Labels 300 & 400 DECT Handsets

1. Status existing labels

2. Proposal with amendments

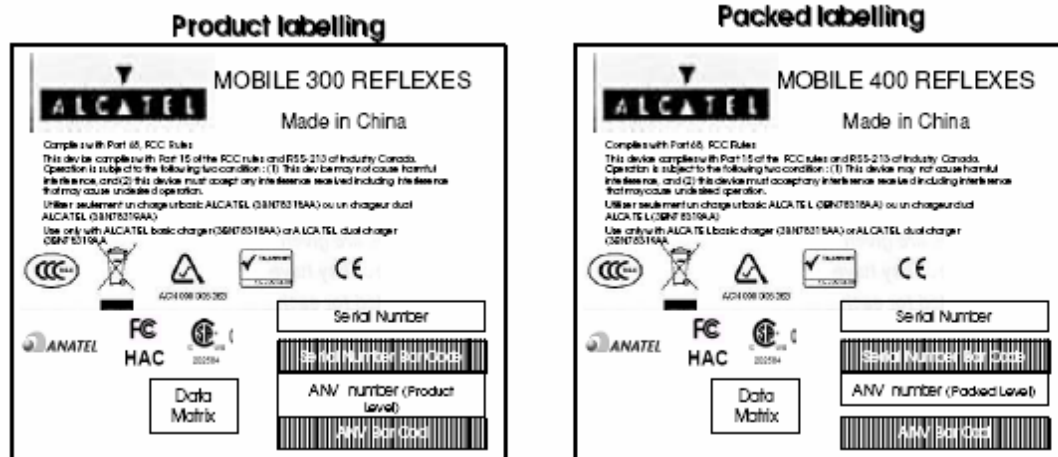
- Europe: CE+WEEE OK
- China : CCC (S&E) OK
- Australia: A-Tick+ACN No OK
-
- NZ:
 - Le Logo Telepermit OK
 - **le No est à venir (PTC....)**
- US et Canada :
 - Logo CSA (C/US) OK
 - **le No sous ce Logo est à venir**
 - Logos : FCC et HAC : OK
 - Il faut rajouter les Nos d'agrément US et Canada :
 - FCC ID : OL3MR300**
(pour MR300)

IC: 1737D-MR300

FCC ID : OL3MR400
(pour MR400)

IC: 1737D-MR400
- Phrase "This device complies with Part 15 of the FCC rules and **RSS-213** of Industry of Canada...."

- Japan: **Supprimer (pas de DECT au Japon; seul PHS)**
- Brazil **- Ajouter Logo Anatel**

- **No d'agrément à venir**
-

Product labelling & Packed labelling

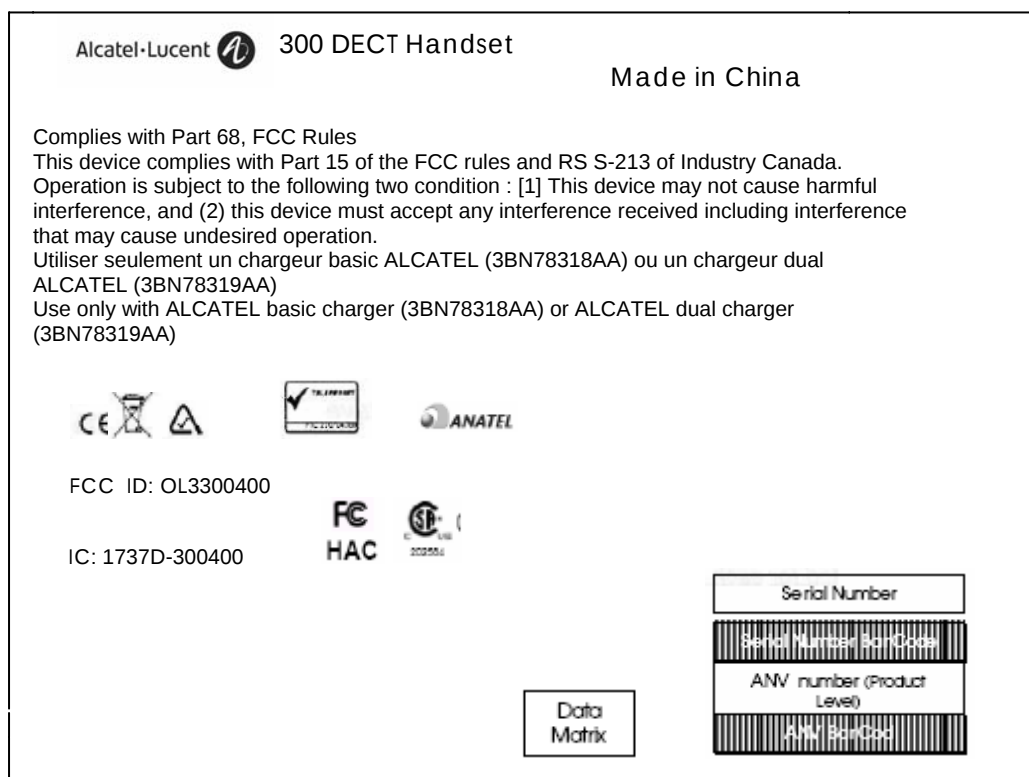
CCC logo removed : not launched in China

- Alcatel Logo replaced by Alcatel-Lucent Logo
- Names: 300 DECT Handset / 400 DECT Handset
- Add FCC ID
- Add IC No
- Australia A-Tick: No CAN No required because Trade name available on Label

- The CSA number under the Logo must be the number given by KTL for CSA Safety approval
- The Telepermit Number only available after NZ approval (if not available remove logo until No available)
